Our ref ER22685

**PLANNING PROPOSAL – SUTTON RD AND FAITHFULL ST,
GUNDAROO (PP-2013-01)**

GUNDAROO VILLAGE

Environmentally Sensitive Areas - Sensitive Water Resources & Groundwater Bores

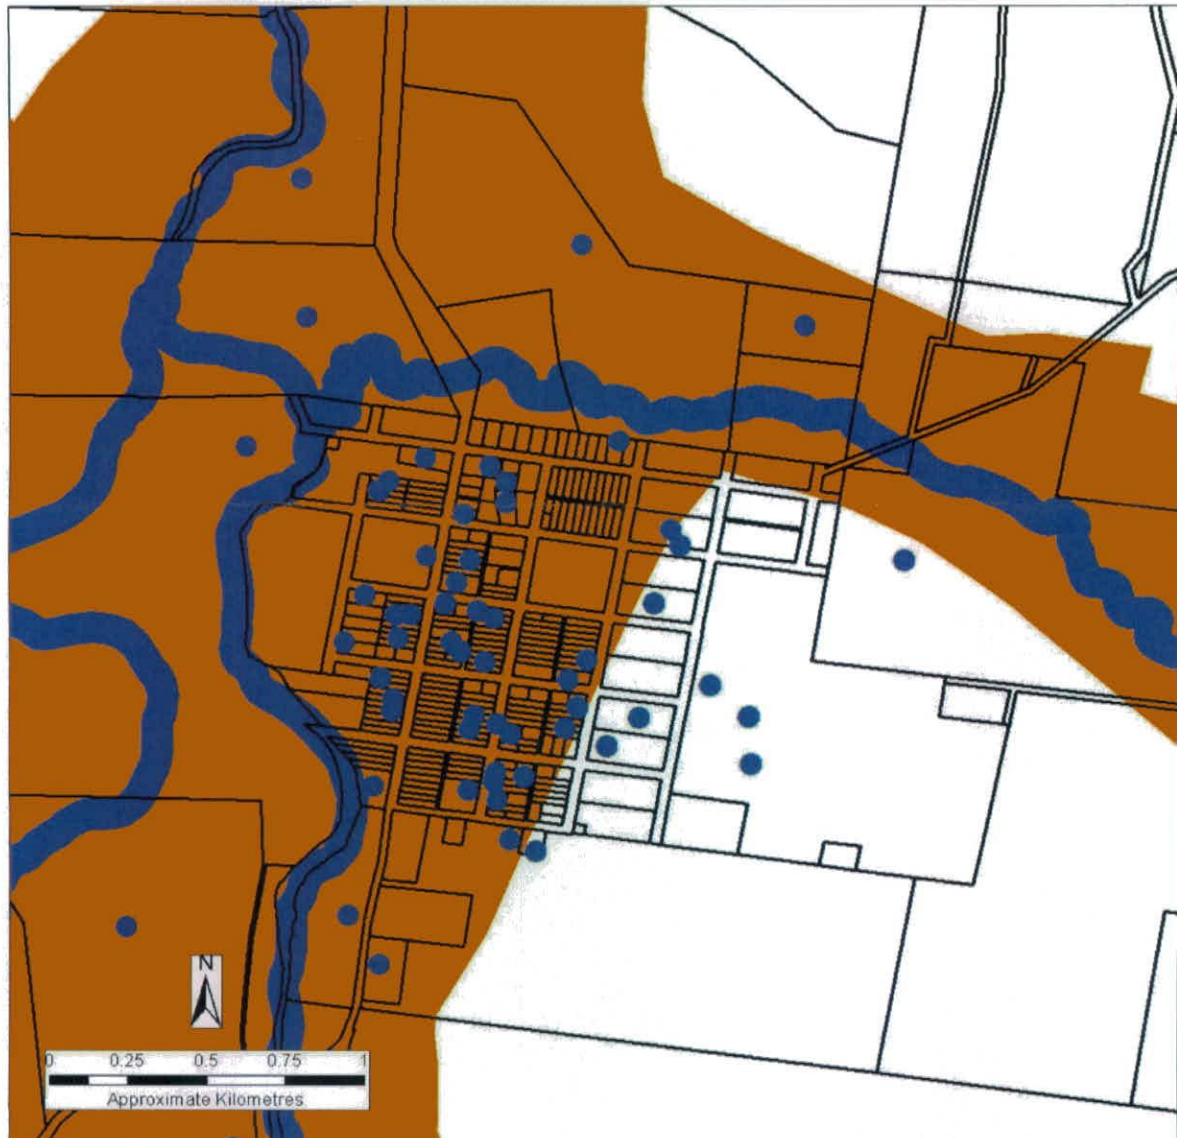
- As shown in Attachment 1 the village of Gundaroo has a high density of groundwater bores. This indicates a strong demand for a water supply source to supplement rainfall collection. It is therefore recommended Council ensure the potential water demands for non-potable and potable purposes have the potential to be obtained from appropriately authorised sources with minimal potential for impact on water users and the environment. A reticulated water supply will reduce the potential for a proliferation of bores, reduce issues of pumping interference, and will improve security of water supply.
